## **Item 7 - Correspondence**

Subject: October 10, 2024 Meeting, Agenda Item #7: Bradley Hills – 5315 Goldsboro Road: Administrative Subdivision Plan No. 620240130 & Final Forest Conservation Plan No. F20240640 (Public Hearing)

**Purpose:** To Provide Community Comments re: **Revised COMBINED STORMWATER MANAGEMENT CONCEPT/SITE DEVELOPMENT STORMWATER MANAGEMENT PLAN for 5315 Goldsboro Road – Proposed Lots 35 & 36**, DPS Letter dated July 12, 2024

**Administrative Subdivision Plan No. 620240130**

# New LOD Concern and Inadequate Erosion Mitigation

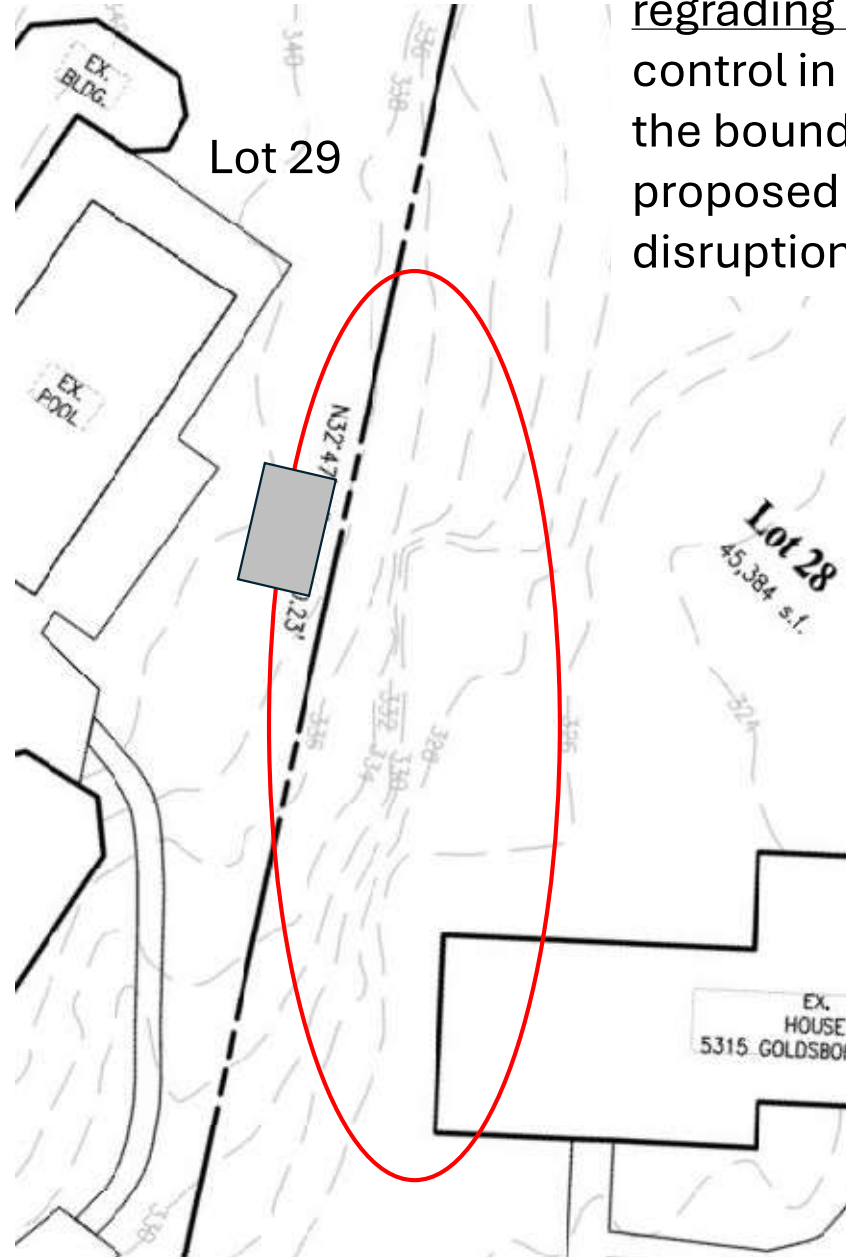
As we have stated, the present brick retaining wall is more than 50 years old and is showing signs of joint decay and cracks. This side of proposed Lot 36 is the steepest on the property. It is immediately adjacent to our pool equipment (pumps, filters, etc., grey box)

The current concept plan states merely to repair as necessary and replace other crumbled walls with new wall.

We request that a **NEW** multi-tier (e.g., 2) retaining wall system be put in place with regrading of each tier to ensure erosion control in this steepest area (red circle) of the boundary between Lots 29 and proposed Lot 36, especially with the disruption of tree removal and replanting.

Current property situation

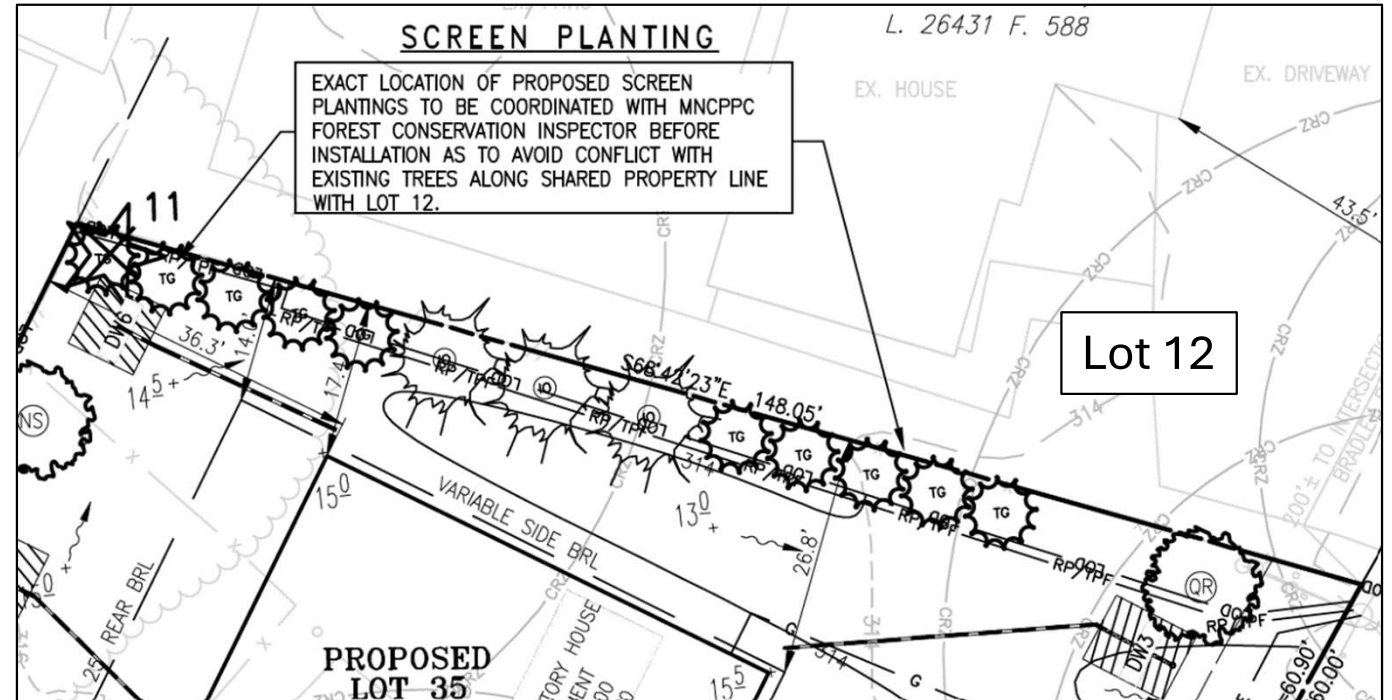
The currently proposed placement of the single-family dwelling on Lot 35 poses a *significant loss of our currently existing privacy (>60-75' lines)* between our property and 5315 Goldsboro Road. The proposed BRL cuts this to **as little as 14'** at our backyard.

We acknowledge the revised concept plan to increase the screening tree density along our lot boundaries but suggest old trees **be removed** and **high growing** screening trees be substituted.

Moreover, we direct the Board to require a **solid fence of the allowed 6' in height** be installed to replace the existing low chain link fence (right picture) and the old wood deteriorating fence (left picture).

## STORMWATER

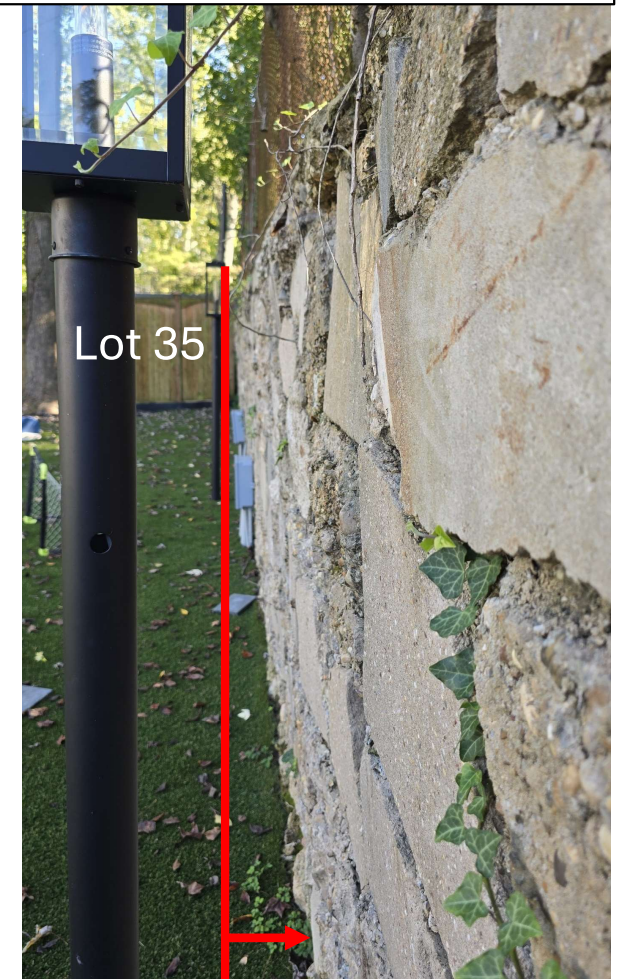
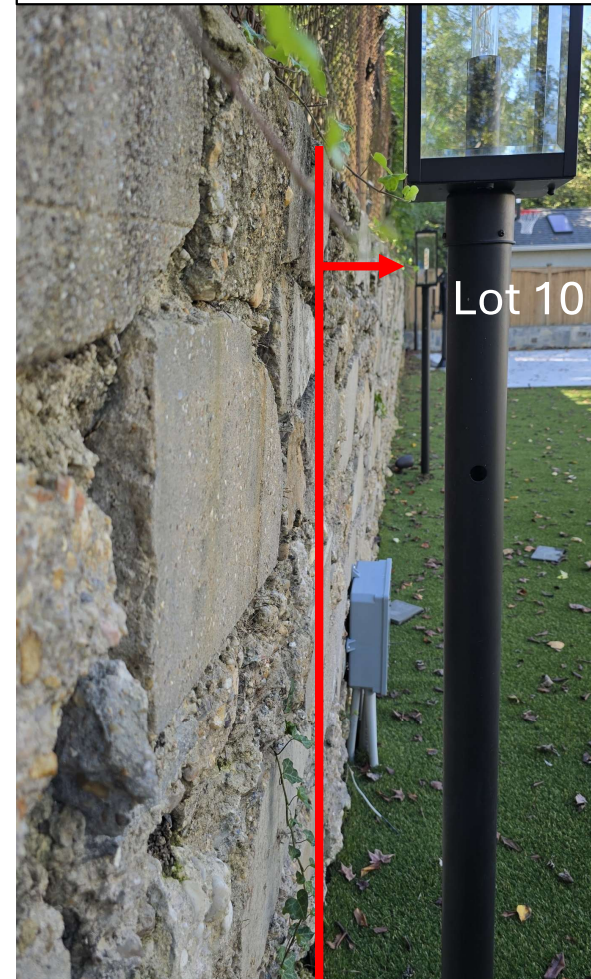
**MITIGATION:** Medium to heavy rainfall over the years results in our backyard flooding and has created corrosion and blocked drain holes in the ~16” wide retaining wall between our Lot 11 and proposed Lot 35.

The property conditions along proposed Lot 35 have created both **water overflow** into our yard as well as **increased subterranean water pressure** causing a bulge or forward leaning (*compared to the parallel vertical red lines*). This is the current condition requiring **a complete stormwater mitigation** along our lot. Not just a “structural analysis” as proposed for DPS (July 12, 2024)

**Location #B-2B**

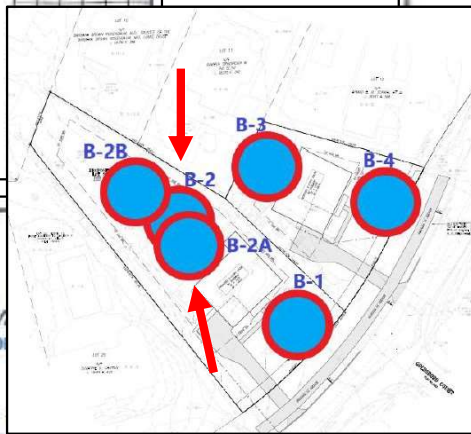
INCONCLUSIVE

Boring terminated – “refusal” @ 2-2 ½ ft.

INCONCLUSIVE

COMPLETELY POROUS SUBSOIL ALLOWING GRAVITY FLOW AND WATER PRESSURE BUILDUP ALONG LOT 10.

## **Recommendations** (excerpt in part):

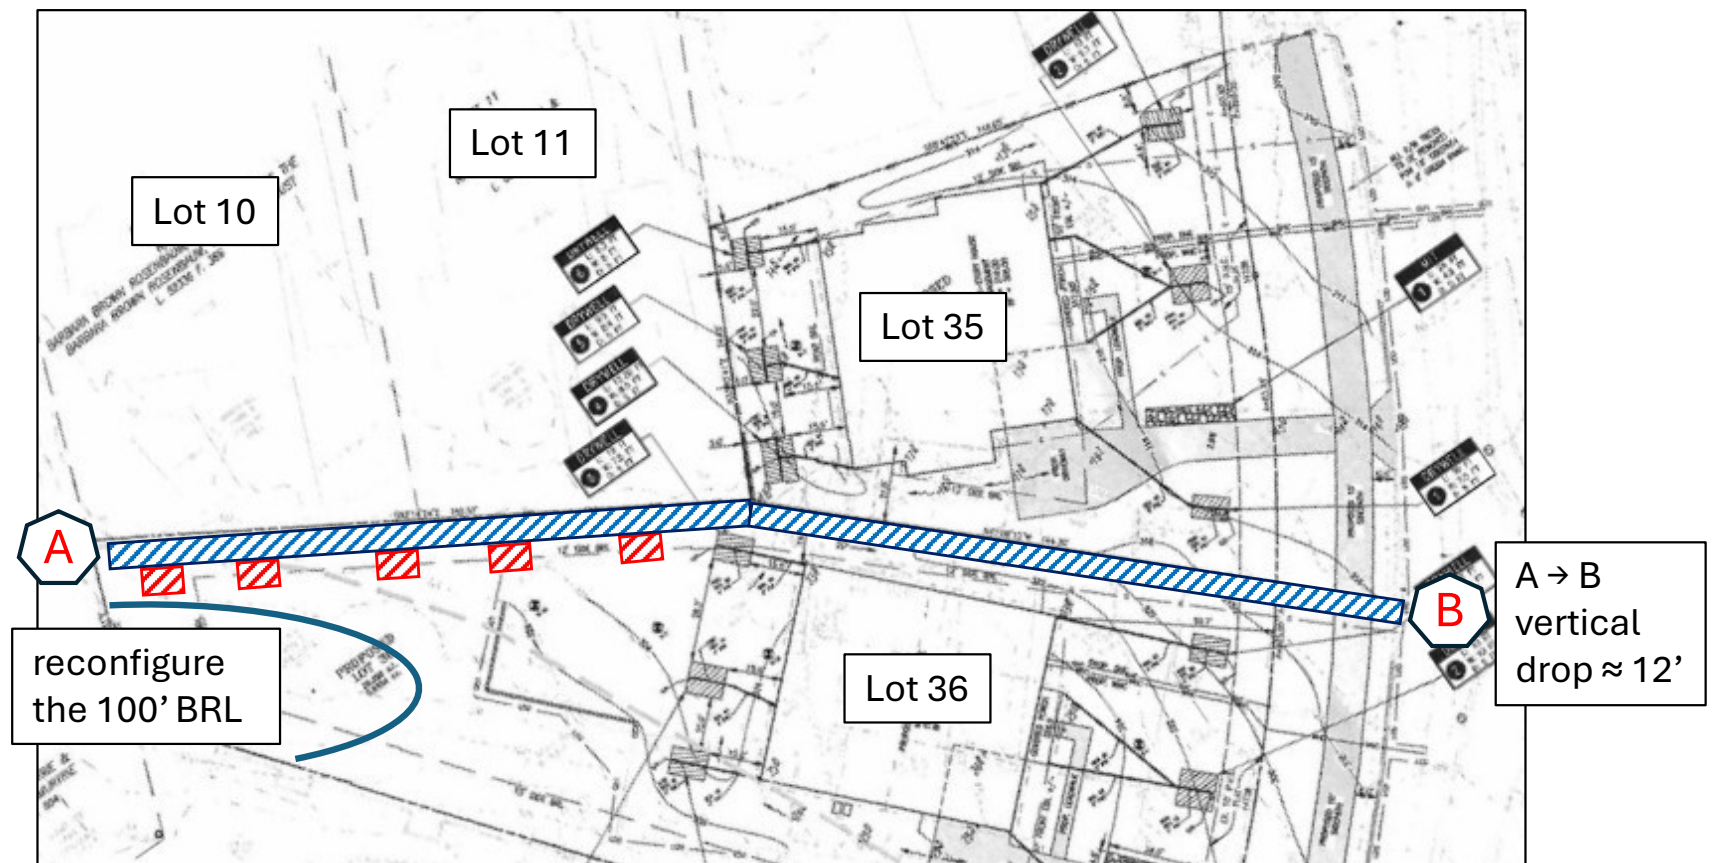
While we do not disagree with DPS (July 12, 2024) that “*a structural analysis of the existing retaining wall must be conducted prior to approval of a sediment control permit for construction on proposed lot 36, to determine the effects of proposed construction traffic, excavation, stormwater management practices, and any related construction activities on the structural integrity of the wall.*”, this requirement falls very short of what is required.

What is required, and can be readily incorporated into the existing concept plan by CPJ is a **stormwater collection, diversion and removal** system from the lot boundaries between proposed Lots 35/36 and Lots 10 and 11, with consideration to not simply rely later on contour flow across toward Lot 12 to Goldsboro Road.

Such a system *could be* comprised of a series of dry well collection points (red) feeding a french drain (blue) taking water away from Lots 10 and 11, and between proposed Lots 35 and 36 for deposit to Goldsboro Rd. to stormwater drains.

Dry well collection alone is not a solution as this promotes subterranean water reabsorption, not redirection and removal.
